**RE: Town of Winnipeg Beach, File 74.30, Lagoon Upgrade EAP  
Additional Information Request #2**

## 13-8588 – Winnipeg Beach Lagoon Upgrades EAP Response to Additional Information Request #2

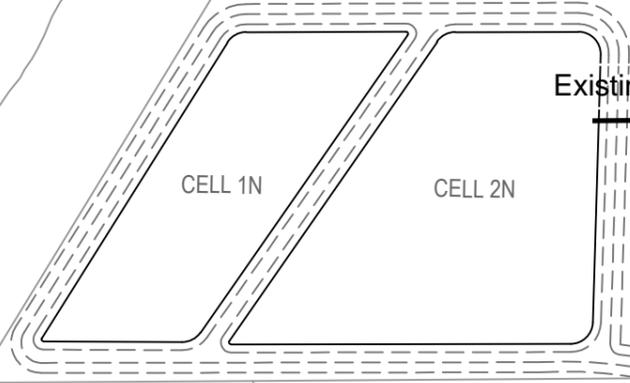
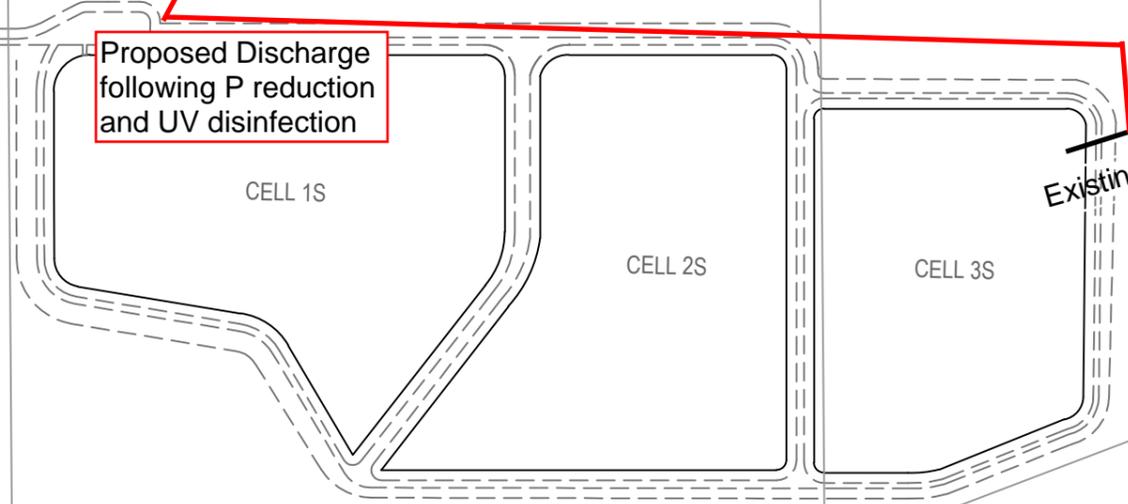
**Question 3:** *[Please provide] confirmation of the proposed location(s) and number of discharge points (a drawing identifying the discharge routes and points will be helpful for increased clarity).*

**Response 3:** A sketch indicating the existing discharge points and the proposed discharge point is attached to this letter.
